Access Compliance Report Public Rights-of-Way (Curb Ramps)

Intersection ID: 27687 Main Street: BALLANTYNE_COUNTRY_CLUBross Street: LEE MANOR_LN Location: SW

ADA ID: 69712698EBDD Ramp Type: Perp Initial Pass/Fail: Fail **Overall Compliance: No** Severity Score: 13.75

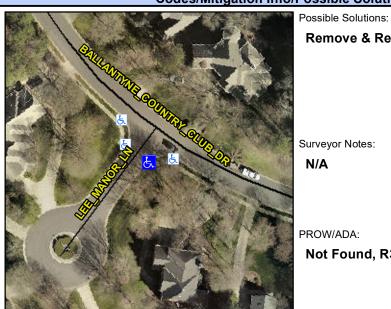
Remove & Replace Entire Ramp. Surveyor Notes: N/A PROW/ADA: Not Found, R304.2.2, R304.5.3

Field Measurements/Component Compliance					
Compliance Description Da		Data	Comp	liance Description	Data
N/A	Ramp Length (in)	48.0	No	Ramp Slope (%)	9.2
Yes	Ramp Width (in)	48.0	No	Ramp XSlope (%)	2.6
N/A	Flare Type LT	N/A	N/A	Flare Type RT	N/A
N/A	Flare Slope LT (%)	N/A	N/A	Flare Slope RT (%)	N/A
N/A	Flare Traversable LT?	N/A	N/A	Flare Traversable RT?	N/A
N/A	Landing Length (in)	N/A	N/A	DWS Provided?	N/A
N/A	Landing Width (in)	N/A	N/A	DWS Contrast?	N/A
N/A	Landing Slope (%)	N/A	N/A	DWS Length (in)	N/A
N/A	Landing X Slope (%)	N/A	N/A	DWS Full Width?	N/A
N/A	Landing Curb? (Y/N)	N/A	N/A	DWS Offset (in)	N/A
N/A	Shared Landing?	N/A			
N/A	Gutter Ponding?	N/A	N/A	Gutter Slope (%)	N/A
N/A	Gutter Lip Ht (in)	N/A	N/A	Gutter X Slope (%)	N/A
N/A	Painted X Walk1?	No	N/A	Painted X Walk2?	N/A
	X Walk 1 Direction	To NW		X Walk 2 Direction	N/A
N/A	X Walk 1 Width (in)	N/A	N/A	X Walk 2 Width (in)	N/A
	X Walk 1 Slope (%)	4.6		X Walk 2 Slope (%)	N/A
